Rev A; 03.04.17

Rev A
 03.04.17
 Issued for Planning

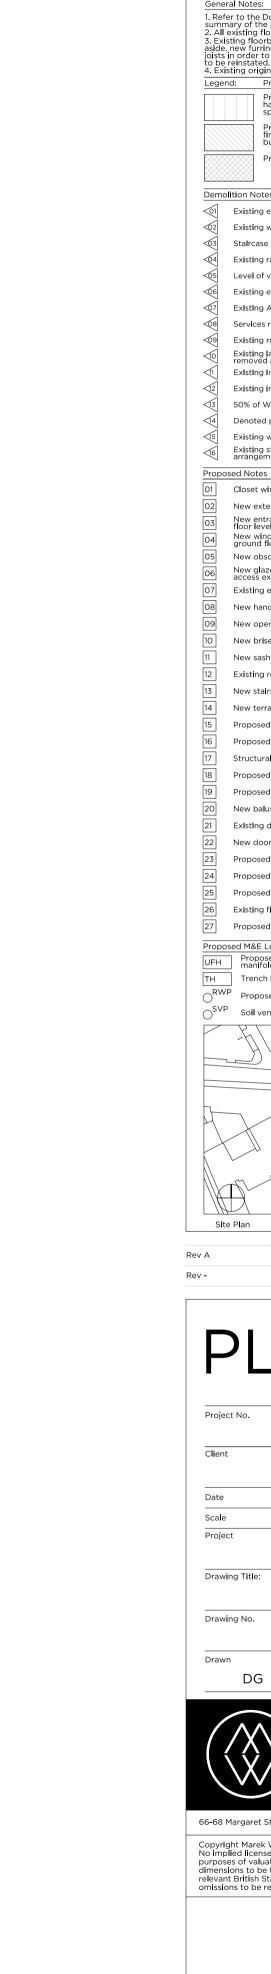
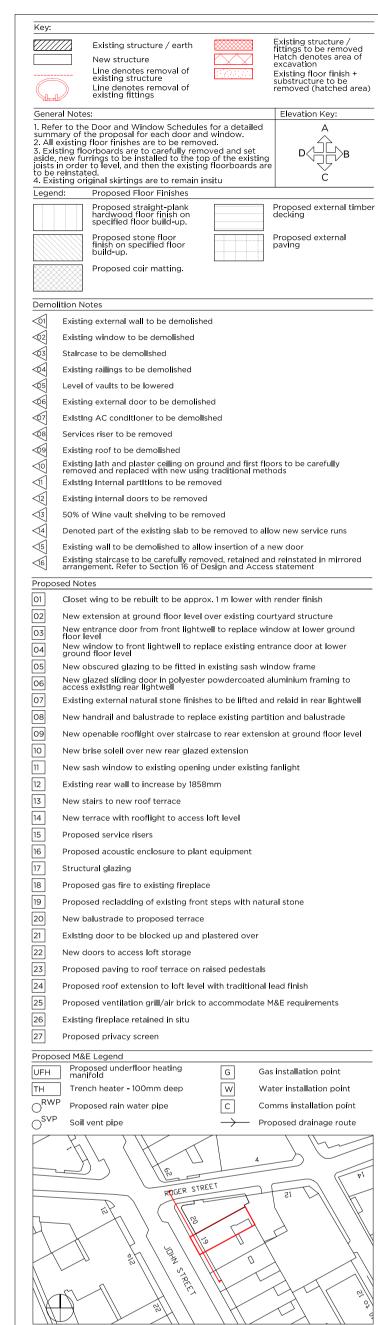
Revised as numbered below:

1. Existing floor to vaults to be retained
